H. B. ROBINSON STEAM ELECTRIC PLANT, UNIT NO. 2
DOCKET NO. 50-261/RENEWED LICENSE NO. DPR-23

**TRANSMITTAL OF EMERGENCY PROCEDURE REVISIONS AND
10 CFR 50.54(q) SUMMARY OF ANALYSIS**

In accordance with 10 CFR 50.4(b)(5) and Appendix E to 10 CFR 50, Duke Energy Progress, Inc. is transmitting revisions to the H. B. Robinson Steam Electric Plant (HBRSEP), Unit No. 2, Emergency Implementing Procedures.

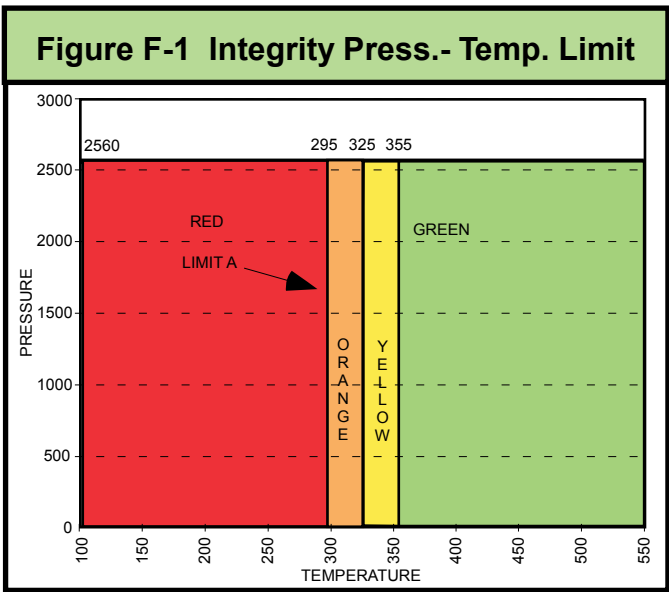
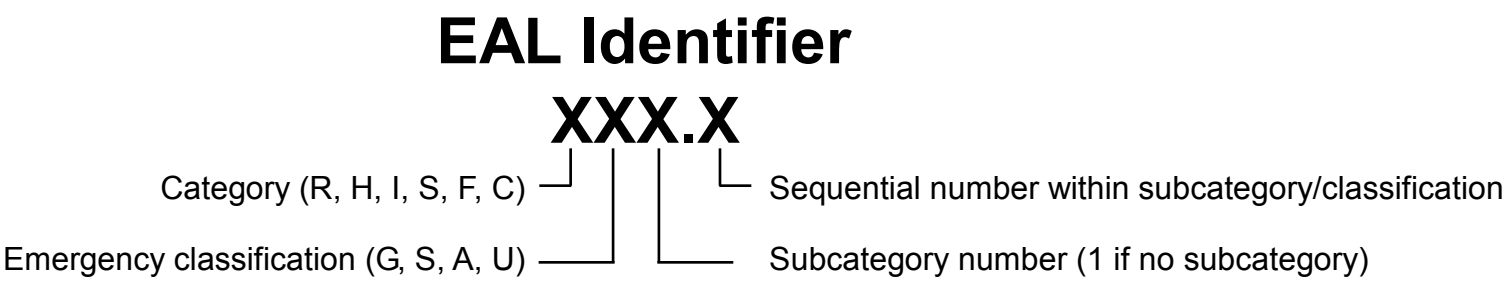
- Table F-1 Fission Product Barrier Matrix Containment Barrier Potential Loss #4 - Added "See Note 4 below".
- Bottom of Emergency Action Level Matrix Hot Conditions - Added "Note 4: R-32A and R-32B may not provide accurate indications for up to **3 minutes** following a sudden significant Containment temperature change such as caused by a Loss of Primary or Secondary Coolant inside Containment. Diverse indications such as R-2, R-7 readings should be referenced to validate R-32A and R-32B.

NOTE 4:
R-32A and R-32B may not provide accurate indications for up to 3 minutes following a sudden significant Containment temperature change such as caused by a Loss of Primary or Secondary Coolant inside Containment. Diverse indications such as R-2, R-7 readings should be referenced to validate R-32A and R-32B.
